MINATO MARU / ENGINE ROOM H1

JS127-ER-H1-03 | CAD implementation amendment | 31 October 2026

CURRENT MODEL SURVEY + ENGINEERING REVIEW

Dimensioned from main f49f22ba82e6 | 31 October 2026 | Units mm; dimensions govern.

Mechanical workshop, engine store and electrical workshop

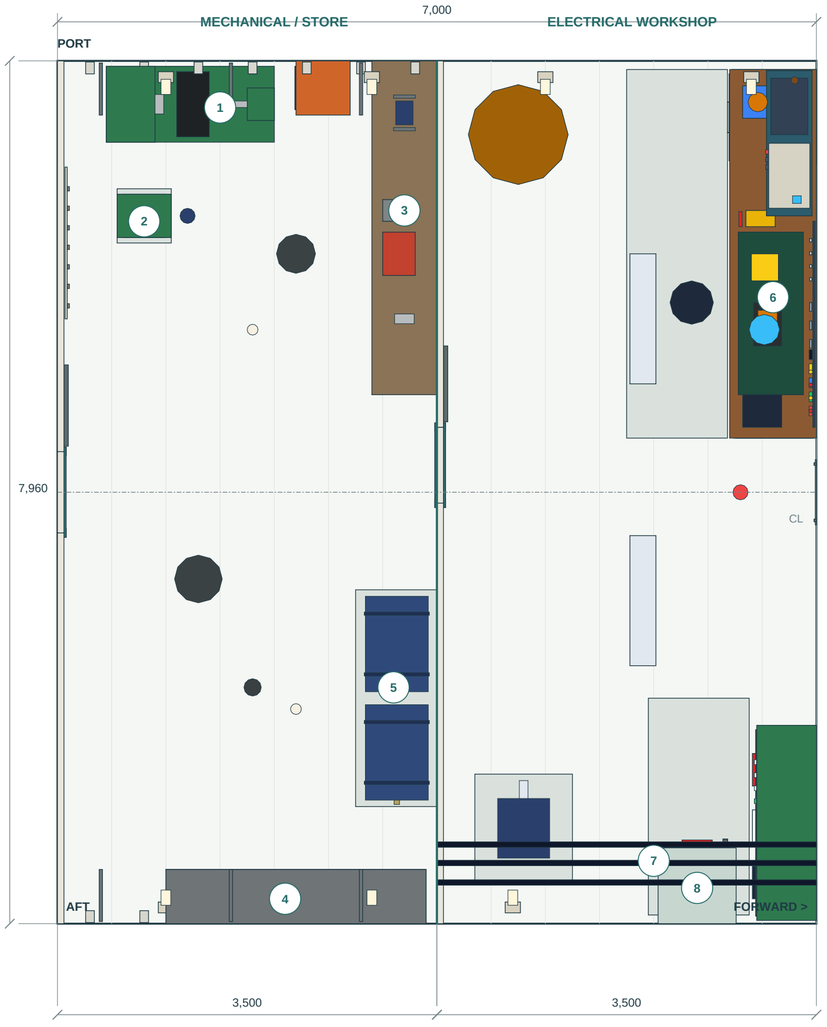
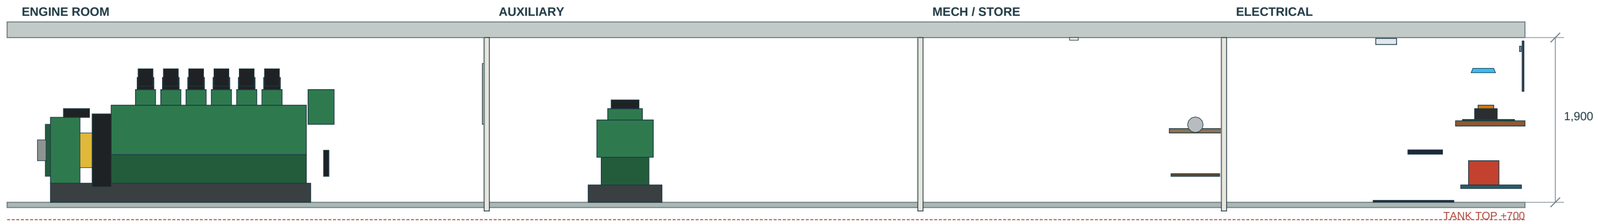
Lathe, pedestal drill, main bench and vice remain. Welding set and grinder remain in the room; hot-work control, screens and extraction are not established by the model.

Spares racks, two oil drums and chain block remain. Mesh partition retained. A stored chain block is not a designed lifting beam or a complete engine-removal scheme.

Existing trunk at X=24,600-25,200 remains. Its through-deck continuation and hatch still need detailing. Do not treat the store as a protected safe escape location.

Current plan only. No machinery, furnishings or compartment boundaries moved. Workshop/store subdivision is the game source; its real damage-stability and fire-division basis is unresolved.

A-A / port machinery centre plane, Y=+1,550

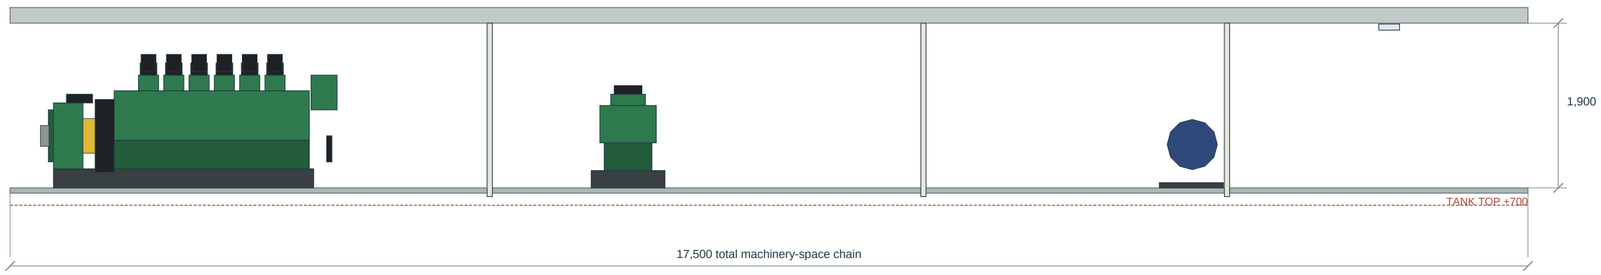
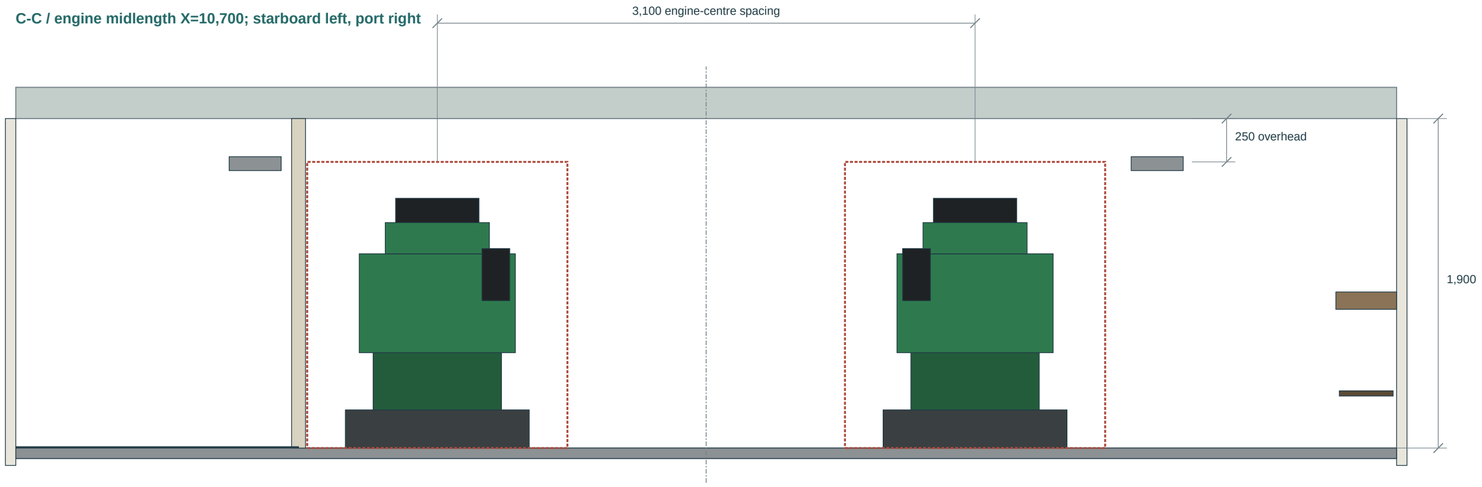
Double-bottom liquid volumes are existing allocations only: two 7.5 m3 fuel-storage tanks; bilge 1.0 m3; sludge 0.3 m3; lube oil 0.6 m3. No individual tank partitions, calibrated capacities or fabrication scantlings are invented here.

The source hull and loading assumptions remain unreconciled. Do not lower the machinery floor, deepen tanks or move bulkheads to manufacture clearance without rechecking hull shape, structure, weights and stability.

Tank top +700; floor plates +900; deckhead +2,800; car deck +3,000. Nominal headroom 1,900 before cable trays, pipes, stiffeners and insulation.

The source grating sits at about +906, on the working-floor level. The 200 mm tank-top interval is service depth, not a walkable lower machinery deck.

The M1 reference reservation rises to +2,550, leaving 250 mm to the deckhead. Piston/liner withdrawal and chain-block hook height are unknown.

Deck beams, tank-top girders, foundation bolts, resilient mounts and lifting points are not fully engineered. The 180 mm model deckhead is an envelope, not an approved beam design.

C-C / engine midlength X=10,700; starboard left, port right

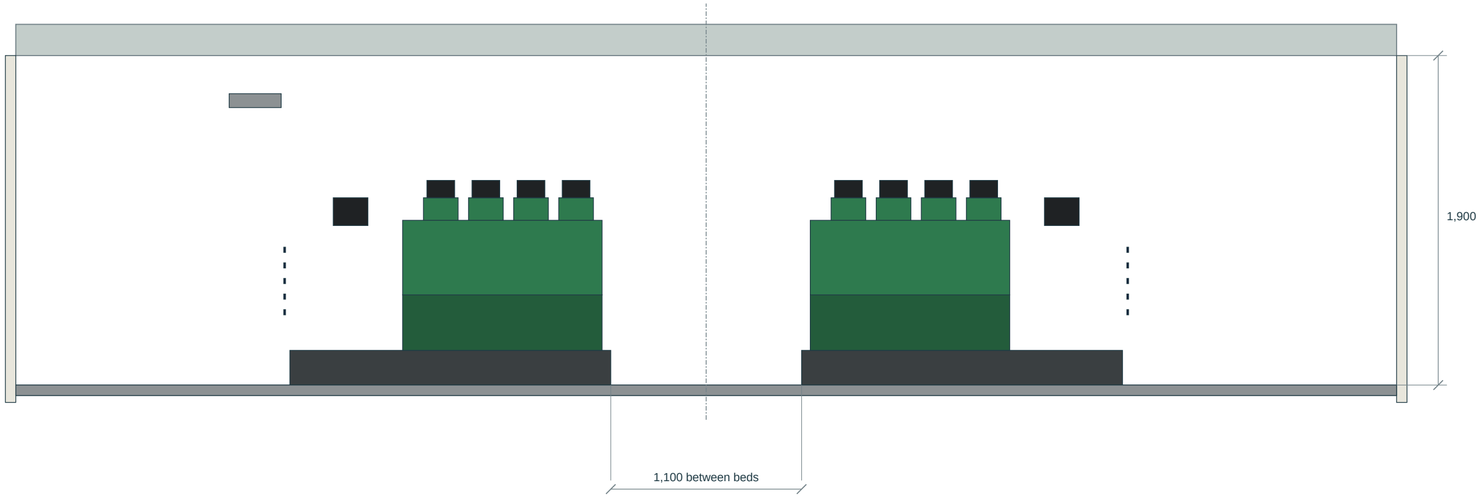
Solid colour is the current game model. Red dashed boxes are retained M1 engine/gear reservations: 2,700 x 1,500 x 1,650, not manufacturer installation data.

A 2,000 mm clear route-height target cannot fit inside the existing 1,900 mm nominal room. Actual piping/trays reduce this further. Do not hide the conflict with a smaller avatar.

Centre aisle is 1,260 mm between actual rail faces. Side access must be checked against fittings, control-booth glazing, valve swing and required part withdrawal, not just a body capsule.

Model a standing operator, kneeling filter service, removal of a rocker cover and the largest planned spare. Keep those envelopes clear before adding decorative props.

Port engine / source elevation; external details only

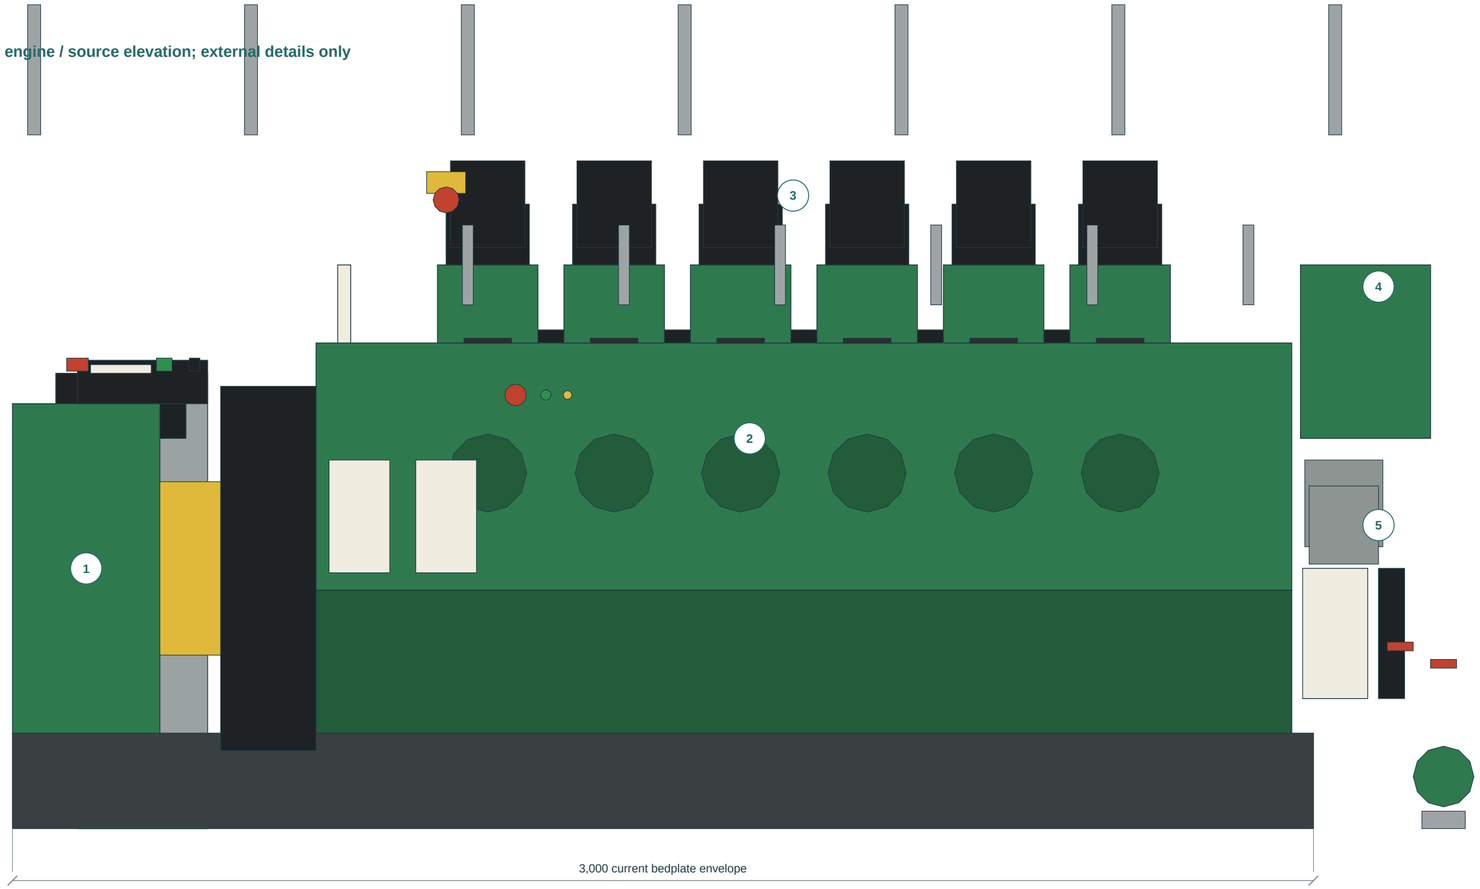
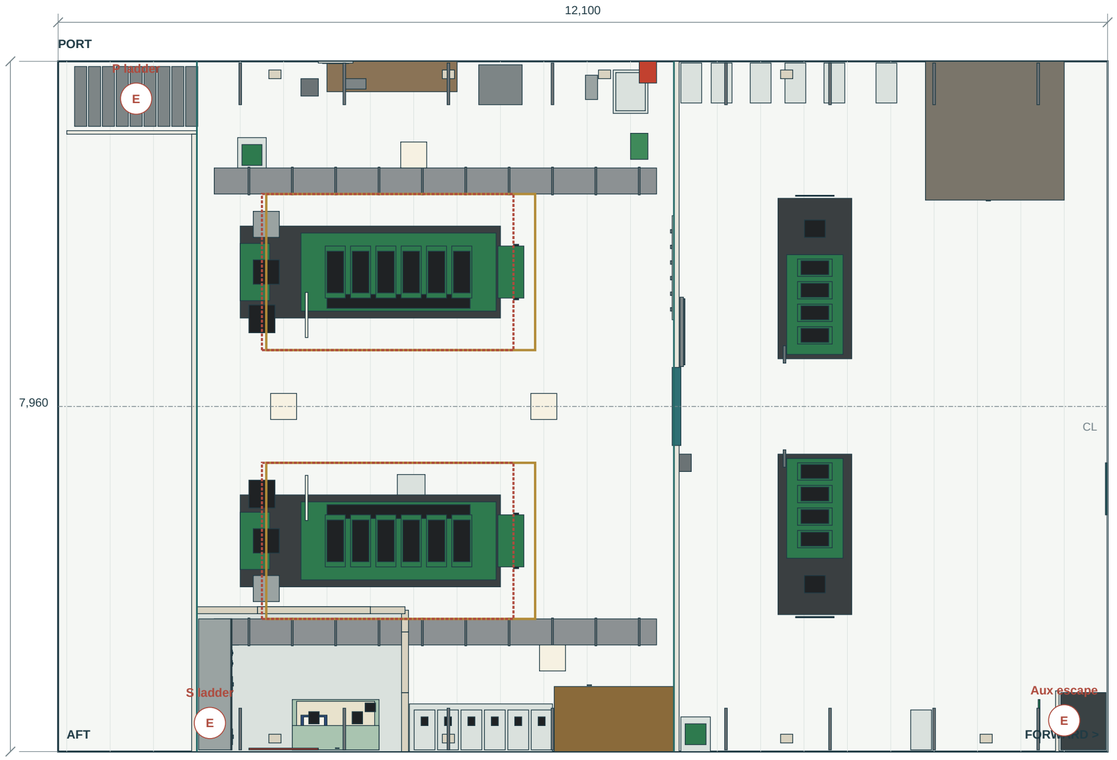
Gear aft, flywheel/coupling between block and gear; propeller shaft leaves aft. Confirm output height, thrust reaction and coupling guard from selected equipment.

Six rocker covers, crankcase service doors, injection equipment and lagged exhaust must read as one coherent machine. A permanently open crankcase cover is inappropriate for the running state.

Turbocharger forward, charge-air cooler and engine-mounted pumps; starting-air, fuel feed/return, LO and cooling connections must each have a separate functional interface.

The retained JM6-160 is fictional: 460 kW / 1,350 rpm / 160 x 200 mm / six cylinders / 24.127 L. A verified Yanmar 6AYM-WST reference is 485 kW at 1,900 rpm, 155 x 180 mm and 20.379 L. The legacy outline is 2,000 x 1,305 x 1,431 mm engine-only; a YX181 package has 2,364 mm combined length. Do not mix those ratings, masses, starting systems or installation dimensions.

Drawing decision: retain installed count, purpose and shaft orientation. Obtain a period-credible matched engine/gear installation basis before replacing the fictional envelope with a detailed production asset.

Port ladder / actual rise and run

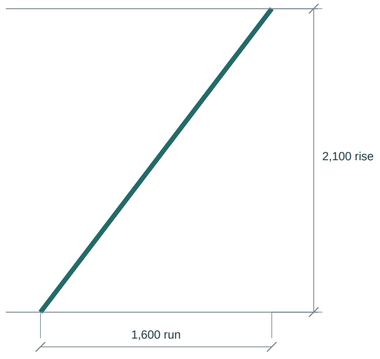
750 mm ladder width. This is a geometric screen only; hands, hatch, head clearance and protected route are unresolved.

Trace both exits from the lowest occupied level to an unobstructed safe deck, including closed-door states. Current aft S ladder has 400 mm rung span, but no complete protected trunk is established.

The present booth has one doorway back into the machinery space. Review an independent sheltered way out; do not count a view through glazing, an oil store or a locked room as an exit.

The prior 3.6 t machinery allowance plus 0.4 t rigging is a planning 4.0 t lift only. No beam, padeye, hook-height, open-deck crane path or through-car-deck closure has been proved.

Reserve removal openings only after coordinating vehicle loading, deck girders, watertight/weather closures, hatch handling, shore crane reach and lift stability.

Services coordination / geometry-screened routes and open connections

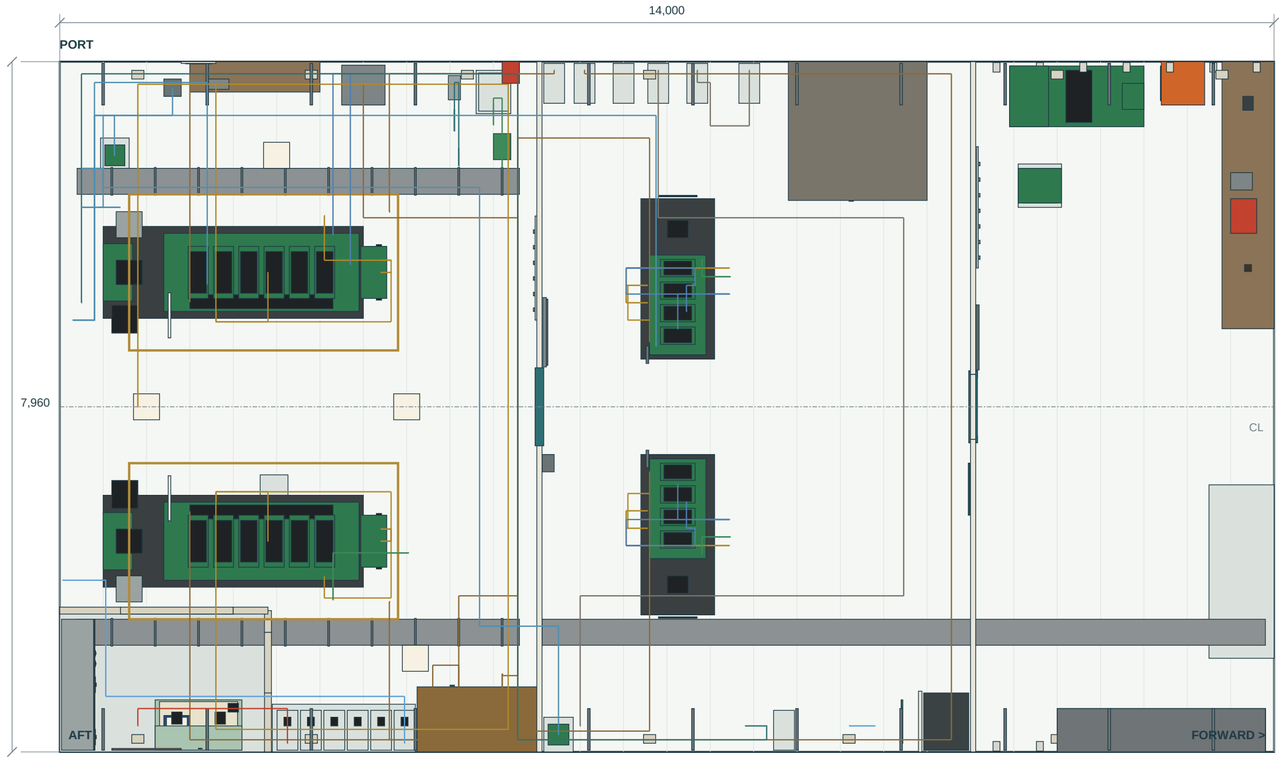
Only the 55 current geometry-screened routes are shown. Their nozzle definitions and fabrication design remain unverified.

206 positive-bore physical connections: 55 geometry-screened and 151 unresolved. Four further graph edges are signals. The 172 coloured game preview paths are excluded from the engineering-route overlay.

Current main still states 1.8 m gravity head. Model service outlet Z=2,200, engine feed Z=2,050: only 150 mm interface elevation difference, not tank operating head. C1 already removes the unsupported assertion.

For each pipe: identify origin, destination, bore/class, flow direction, valves, drains/vents, supports and bulkhead sleeve. Preserve maintenance and escape envelopes; a coloured line alone is insufficient.

Prove combustion and heat-rejection airflow with ducts and dampers; thermally separate exhaust from oil systems; define protected volumes and extinguishing boundaries before sizing or adding detail.
